TO: Advisory Board on Radiation and Worker Health Work Group on TBD-6000  
FROM: Robert Anigstein, Joe Zlotnicki, Dick Olsher, and John Mauro, SC&A  
SUBJECT: Review of NIOSH Report on Response of Film Badges to High-Energy Photons  
DATE: October 28, 2011

### **Review of “Evaluation of the Response of Film Badges to High Energy Photons”**

Figure 1. Film Response with 0.020-inch Tantalum Filter (adapted from Brady and Iverson, 1968) (Lalos 1989, Figure 2-5)

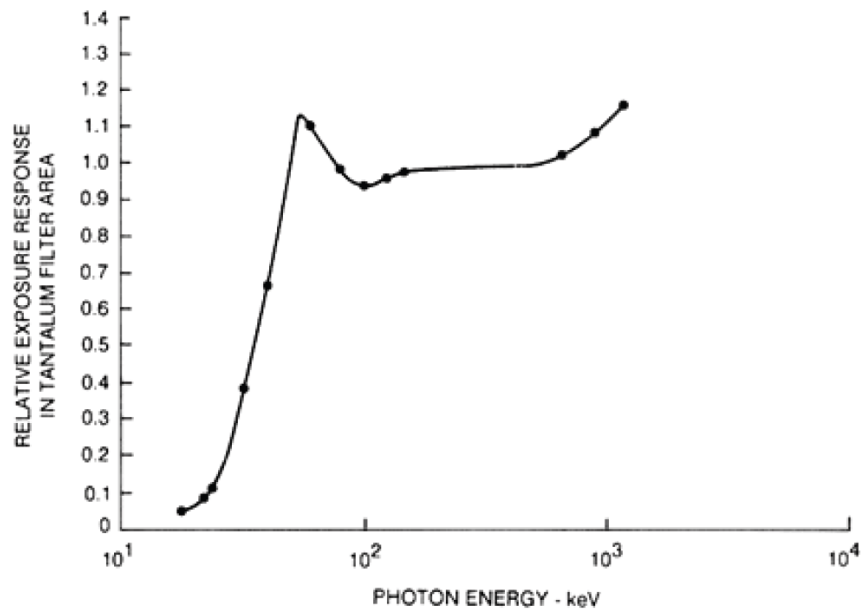
Macievic (2011, Figure 1) illustrated the response of film covered with a tantalum filter to photons with an energy range of approximately 15 keV to 1.2 MeV. Figure 1 in the present memo is reproduced from Lalos 1989, Figure 2-5, the source of Macievic’s Figure 1. As stated in the caption, that figure was adapted from Brady and Iverson 1968; it appeared there as Figure 3. According to these authors: “Figure 3 indicates that, for photon energies from 45 keV

to more than 1 MeV, the tantalum film response for personnel dose is within  $\pm 20$  percent of the cesium gamma air calibration.”

Macievic did not explain what quantity the response of the film is compared to. This question can be resolved by referring to Griffith (2007), who stated:

Macievic (2011) did not indicate the energy of the radiation source used to calibrate the film. According to Brady and Iverson (1968), film badge dosimeters were calibrated by exposing them in air to a  $^{137}\text{Cs}$  source. We independently confirmed the use of this radionuclide as the calibration source by digitizing the data points in Figure 1 and observing that the third point from the right approximately corresponds to an energy of 662 keV (the principal  $\gamma$ -ray emitted following  $^{137}\text{Cs}$  decay) and a relative response of 1.

Macievic (2011) did not identify the type of film used to generate the data in his Figure 1. Brady and Iverson stated that the film was part of the “du Pont Type 556 film packet, including 519 low

range and 834 high range components.” Such information is needed to apply these data to the present issue.

Figure 1 does not include data above 1.2 MeV, although the curve is rising at that point, suggesting a continuing overresponse at higher energies. According to Lalos (1989): “Exposure to photons with quantum energies above 2 MeV may result in a situation in which the density under the filters is greater than the density in the open window area, with the greatest density occurring under the high-Z filter.” This indicates that the film would overrespond to high-energy photons. The low sensitivity of the tantalum-covered portion of the film to low-energy photons shown in Figure 1 is due to the shielding by the tantalum filter. These photons are also detected by the plastic-covered portion of the film, and a processing algorithm uses the readings from both portions of the film to derive the dose to the film-badge wearer. In fact, a major motivation for the original use of metal filters was to account for the overresponse of the unshielded emulsion to low-energy photons, a primary source of radiation exposure of individuals employed in medical radiography.

Figure 2. MCNP Model of New Betatron Building, Showing Locations of Exposure Assessments

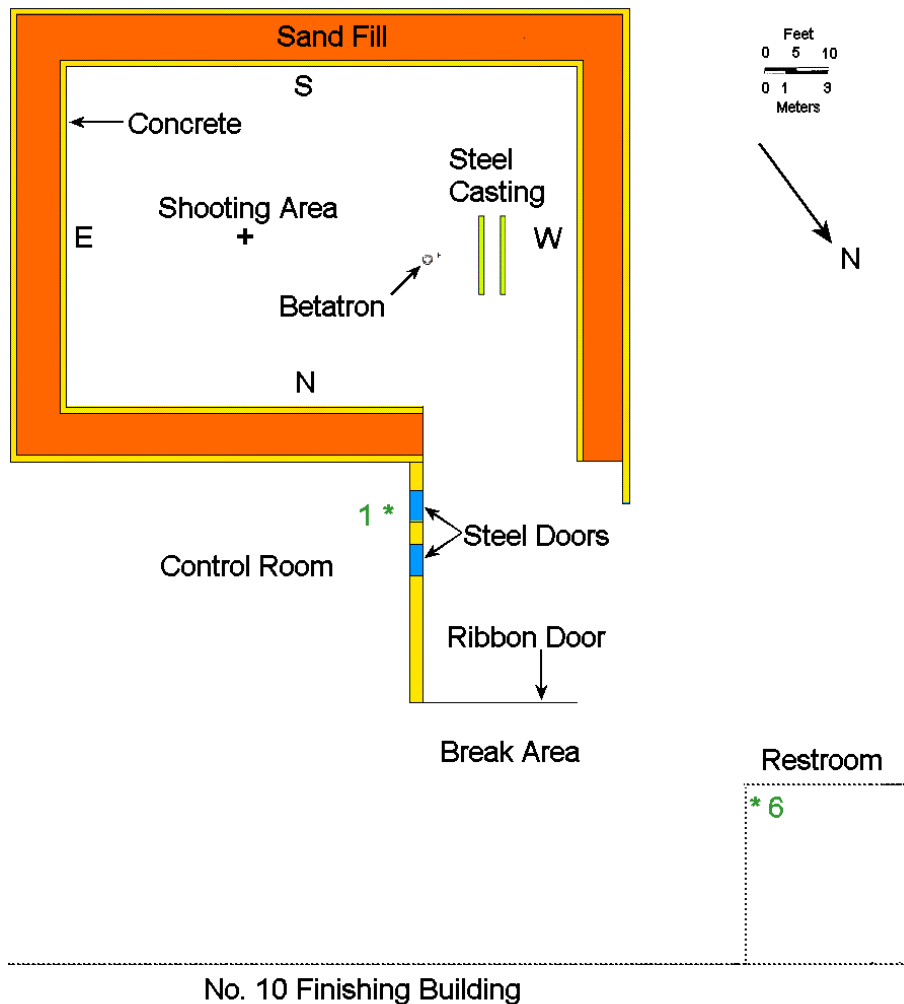
In order to resolve the lingering questions posed by Macievic (2011), we performed an independent analysis of this issue. We began by repeating one of the analyses that we had performed in support of a previous report (SC&A 2008). In that study, we used the MCNP radiation transport code to simulate the exposure rates in various locations in and around the New Betatron Building during the radiography of a steel casting. In the current analysis, we used the same exposure conditions, but tallied the exposures in 279 energy bins. We then used these results to generate a table of exposure rates vs. photon energy. Figure 2, which is adapted from SC&A 2008, Figure 14, shows the two exposure locations assessed in the present analysis.<sup>4</sup>

Figure 3. Exposure Rate vs. Photon Energy in Control Room (location #1 in Figure 2)

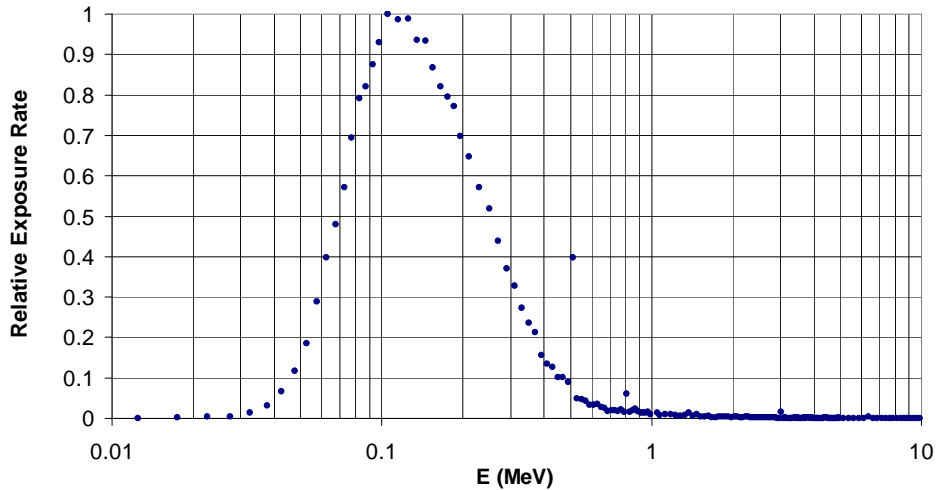
Figure 3 shows the exposure-rate spectrum (i.e., exposure rate vs. photon energy) in the control room, near the door to the shooting room. Our analysis shows that 99% of the exposure rate is from photons  $E < 3.6$  MeV, while 90% of the spectrum lies between 45 and 540 keV. The exposures in this energy range fall within the  $\pm 20\%$  relative sensitivity range of the film described by Brady and Iverson (1968), as quoted earlier in this memo.

Figure 4. Cumulative Exposure Rate vs. Photon Energy in Restroom (location #6 in Figure 2)

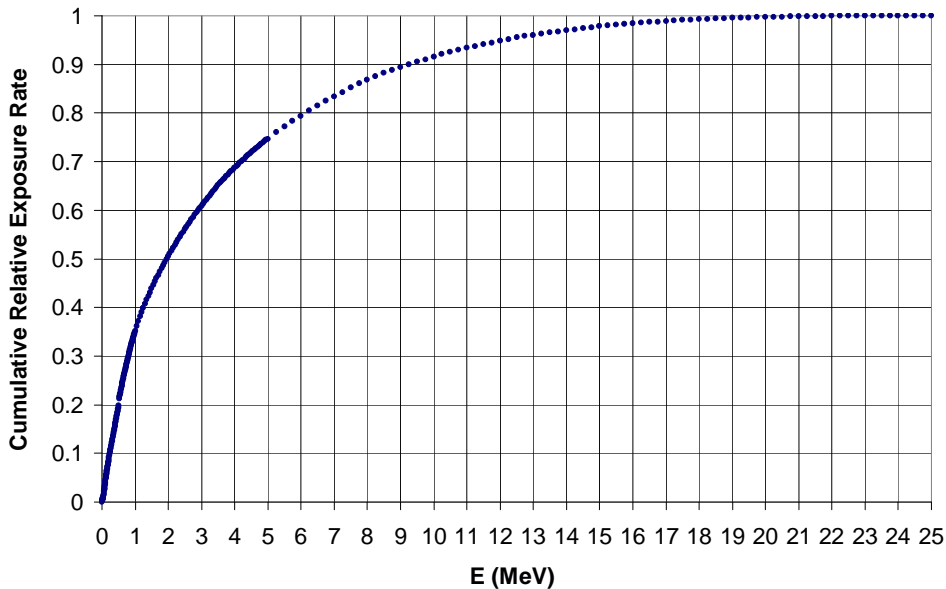
Figure 4 shows the cumulative exposure-rate spectrum in the restroom. As shown in this figure, 50% of the exposure rate is due to photons  $E < 2$  MeV, while 90% is below 9.25 MeV. This analysis was based on the drawings of the betatron building in reports available at the time of the original SC&A (2008) analysis, which indicated only a thin wall along the rail tunnel on the northwest side of the building. A drawing that accompanied the report of a radiological survey

of an 80-Ci  $^{60}\text{Co}$  source in the New Betatron Building (NRC 2009, p. 16) showed that this wall was 2 ft thick, which would have significantly attenuated the radiation field in the restroom. The additional scattering caused by the thicker wall would soften the spectrum, bringing it closer to that in the control room. However, the spectrum derived in the present analysis can be used to represent a limiting case, encompassing other lightly-shielded locations.
